AN ORDINANCE No. 2023-089

To authorize the Chief Administrative Officer, for and on behalf of the City of Richmond, to execute a City of Richmond Grant Contract between the City of Richmond and the James River Association to provide funding for the implementation of green infrastructure improvements to increase stormwater management at a certain library of the City known as the East End Branch located at 1200 North 25th Street. (7th District)

Greening Richmond Public Libraries

RE: Amended Plans
UDC 2022-19
Greening Richmond Public Libraries
East End Branch Library
1200 North 25th Street,
Richmond, 23223

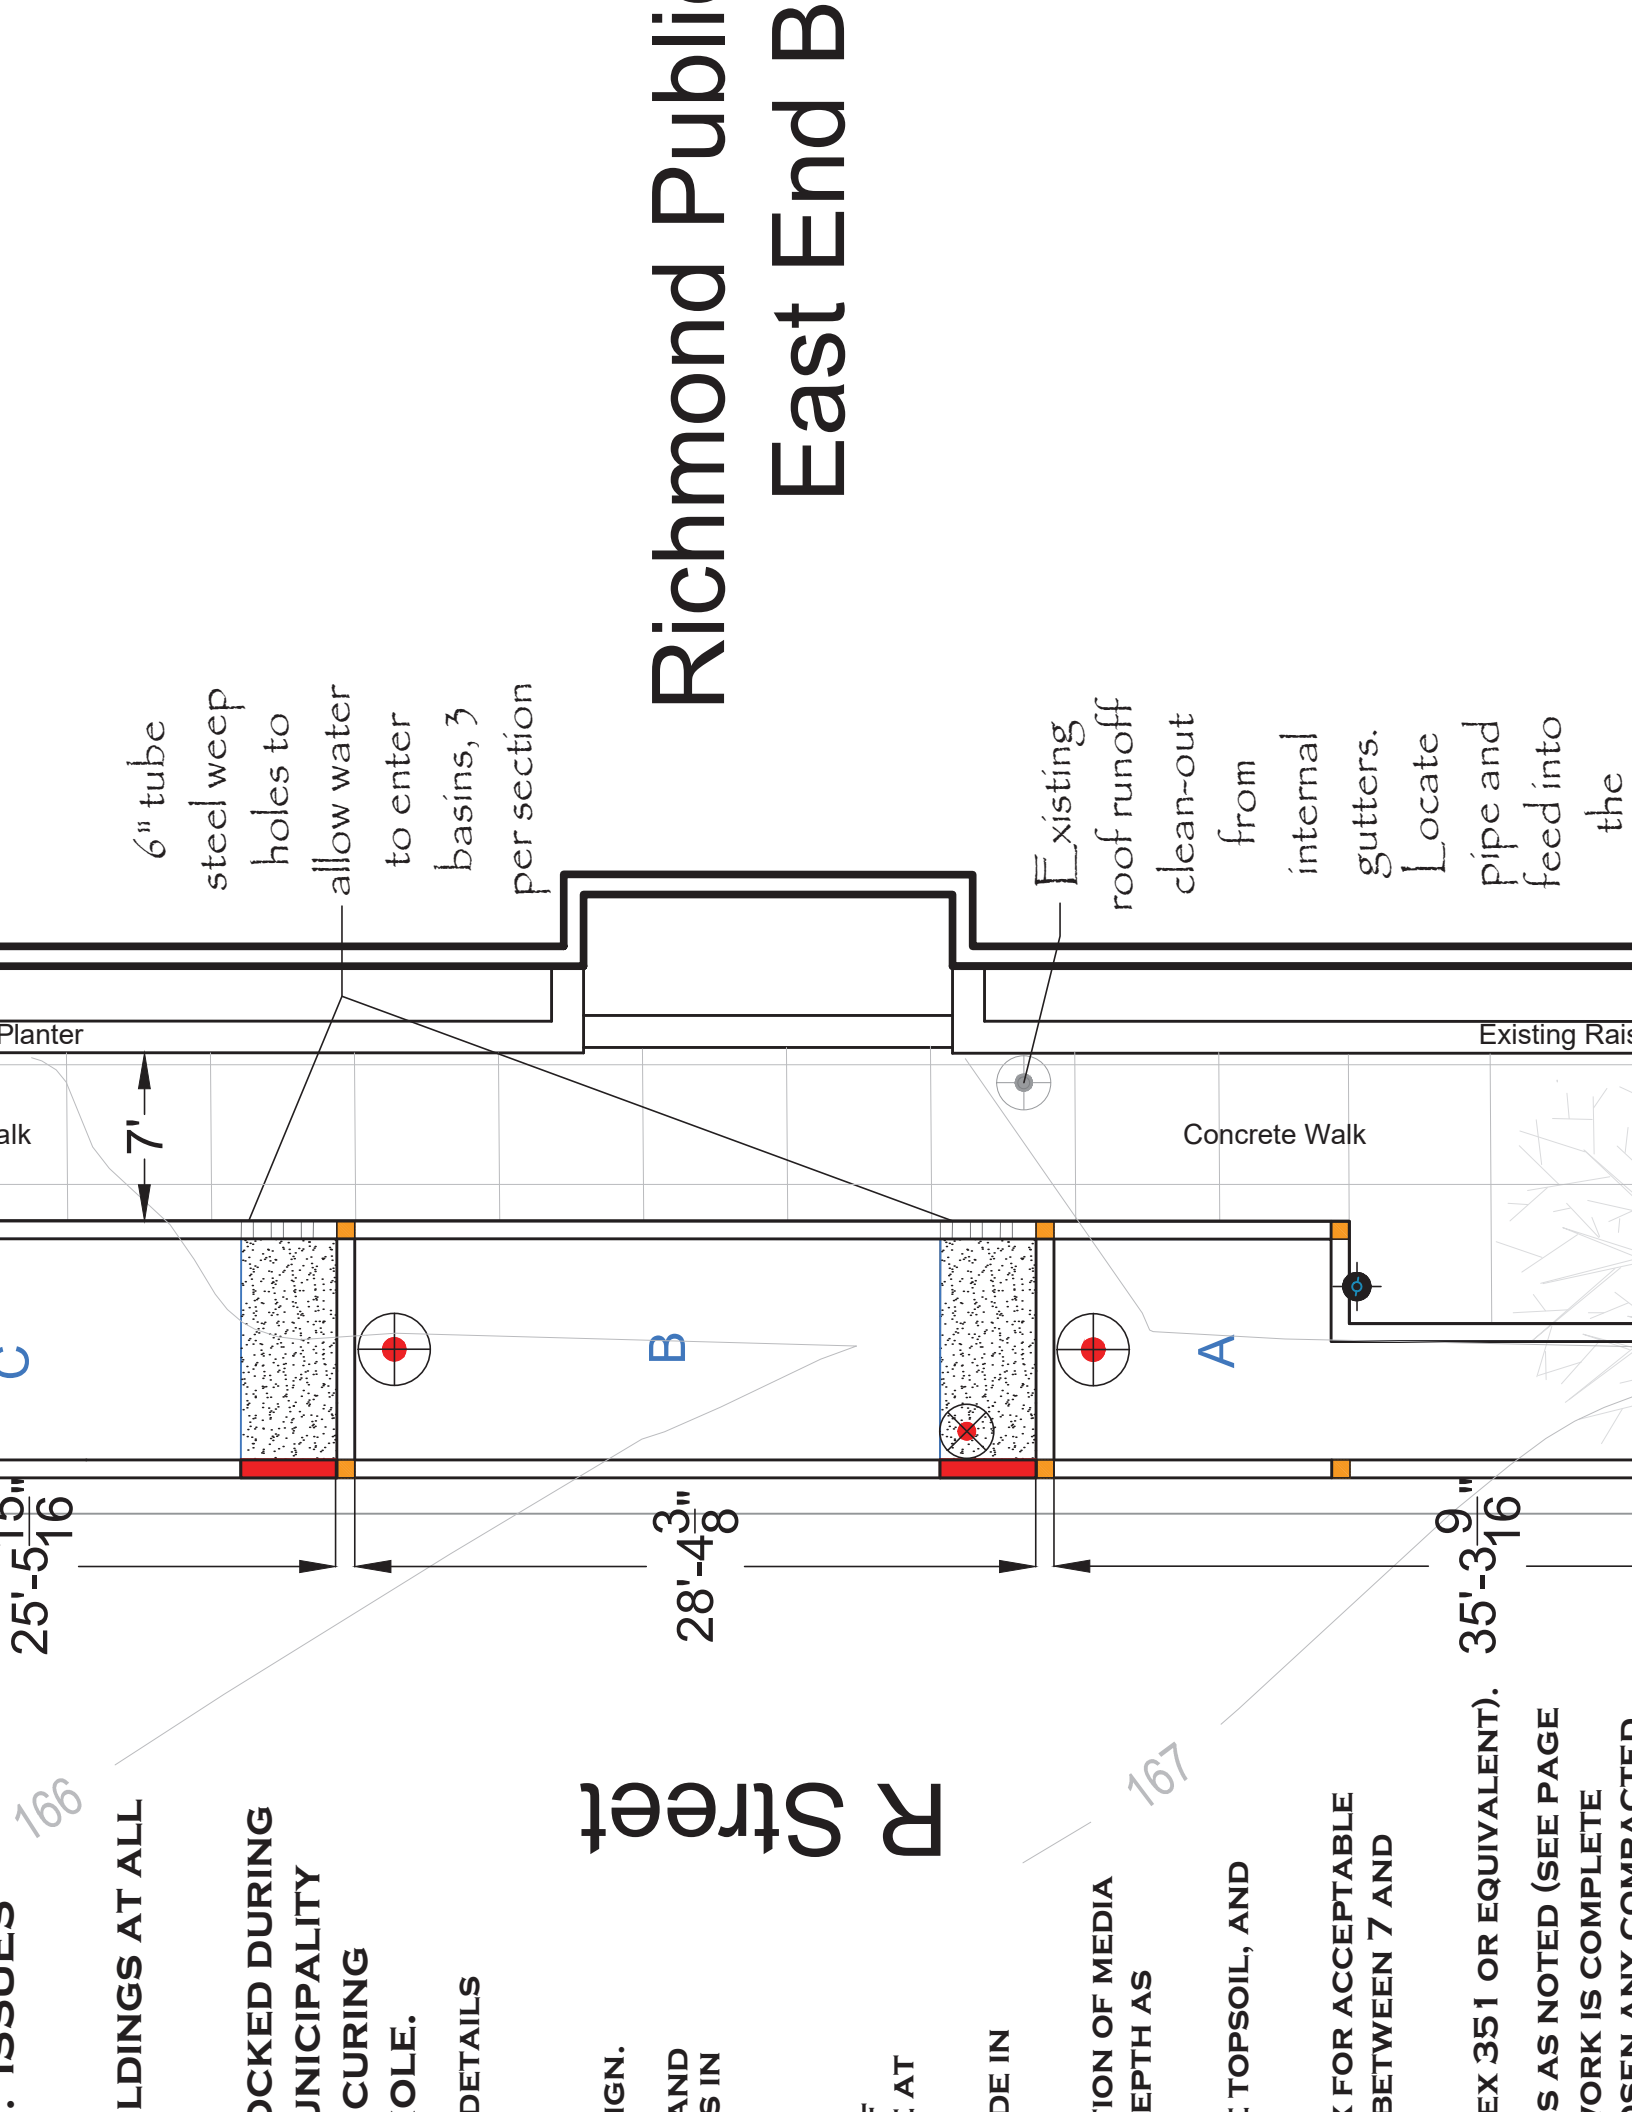
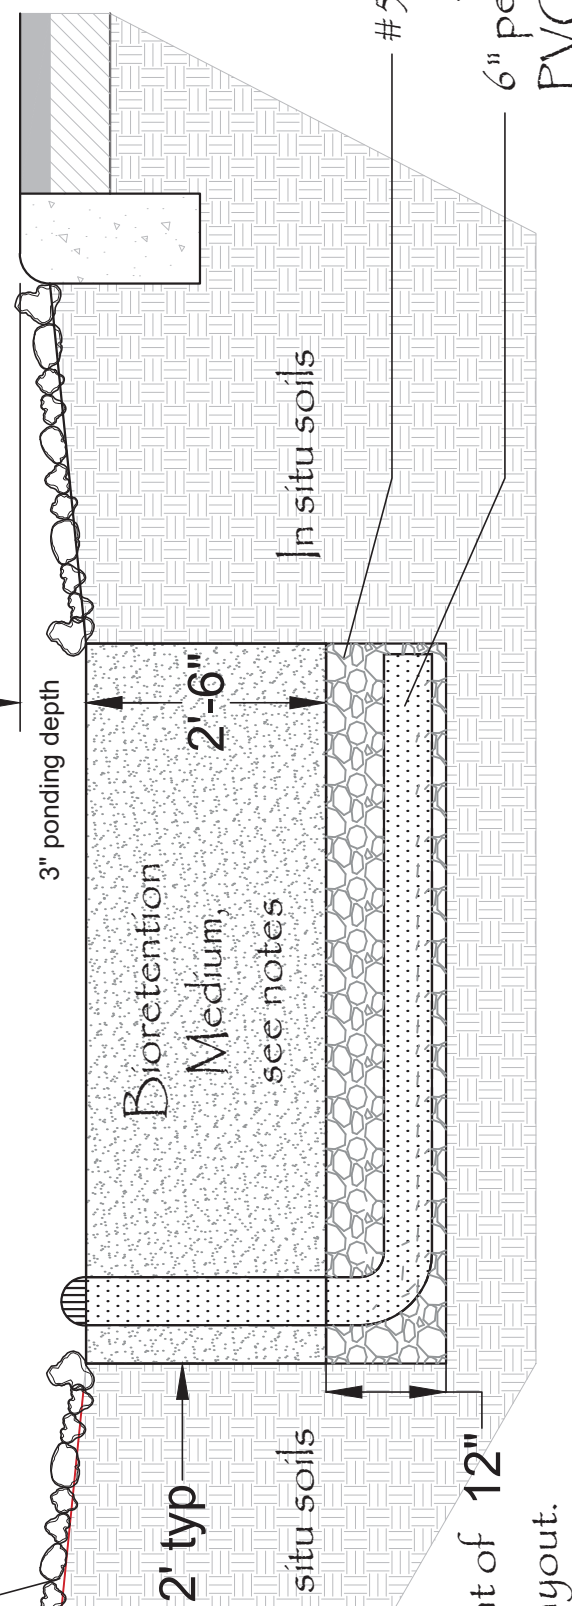
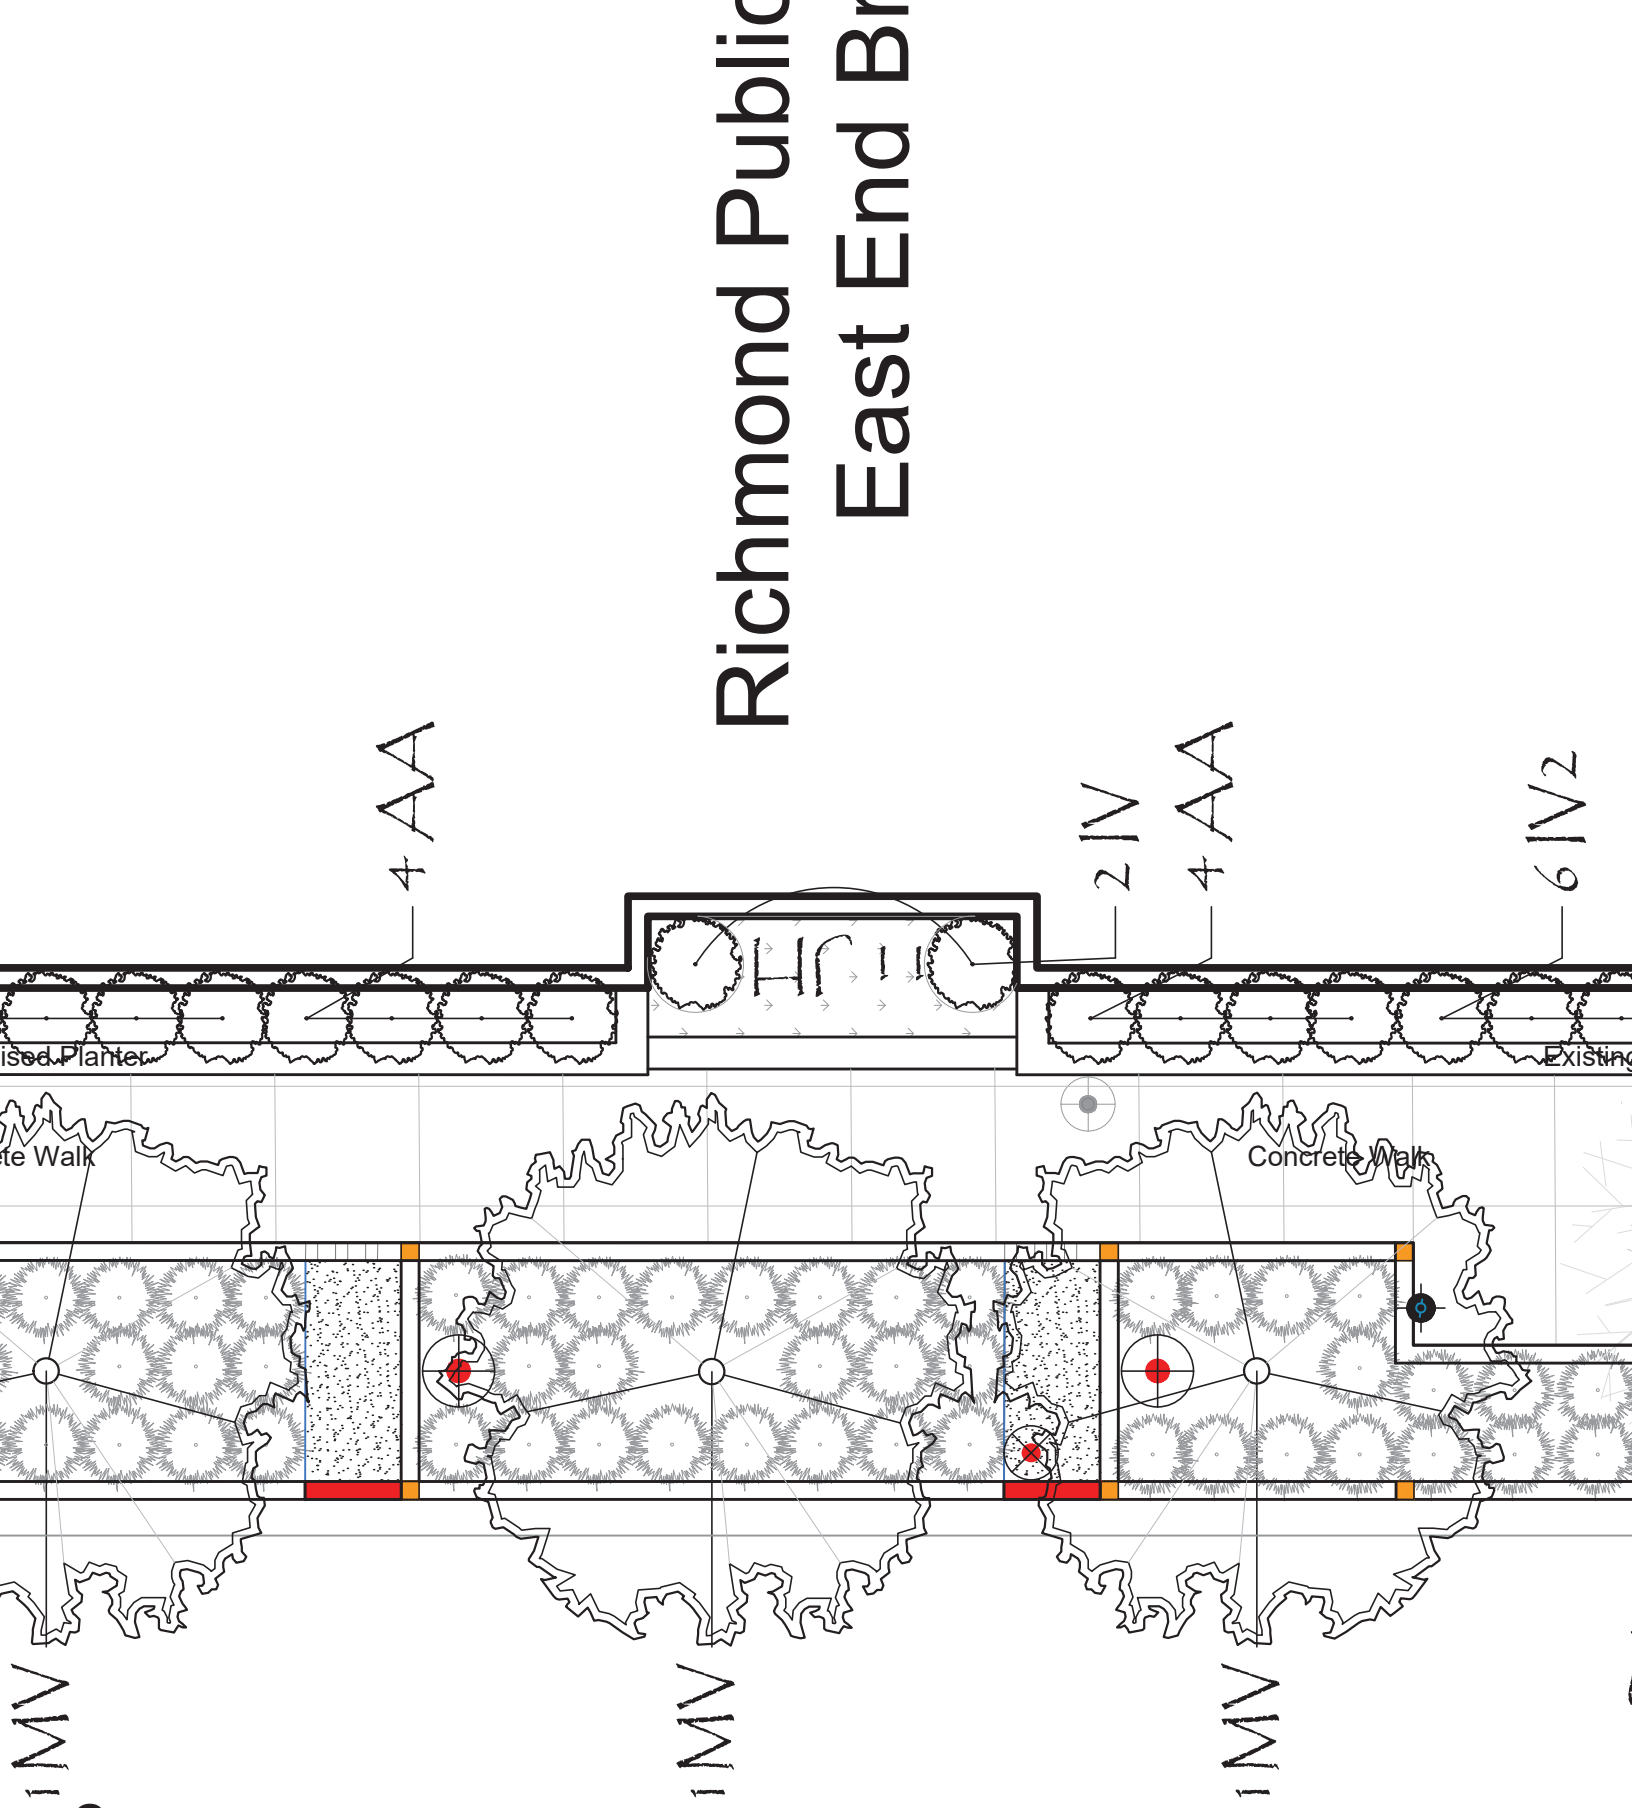
(a): Sidewalks are too narrow? - SIDEWALK WIDTH HAS BEEN INCREASED TO 7' AND IS NOTED ON DRAWINGS.

(b): Concerns Regarding Bollards? - BOLLARDS HAVE BEEN ELIMINATED

(g): Bike Share Power Housing conflicts with walk area in sidewalk. - RELOCATED TO PROPOSED CONCRETE PAD OUTSIDE OF SIDEWALK

(a): Change Fringetrees to Wax Myrtles. - USING A LARGE, FAST GROWING EVERGREEN SHRUB CREATES MAINTENANCE ISSUES. FRINGETREES HAVE BEEN SUBSTITUTED WITH SWEETBAY MAGNOLIAS OR ELIMINATED.

(b): Minimum 10' tree protection zones. - THE EXISTING TREES TO REMAIN ARE PLANTED IN A 5' X 5' TREE WELL. IT SHOULD BE NOTED THAT SOME CONCRETE AROUND THEM IS BEING REMOVED THEREBY INCREASING SPACE FOR THE TREES. FINAL DRAWINGS WILL SPECIFY THAT CONSTRUCTION FENCING WILL ENCIRCLE THE 5' X 5' SPACES AND NO FOOT TRAFFIC OR STORAGE MAY OCCUR IN THAT SPACE.
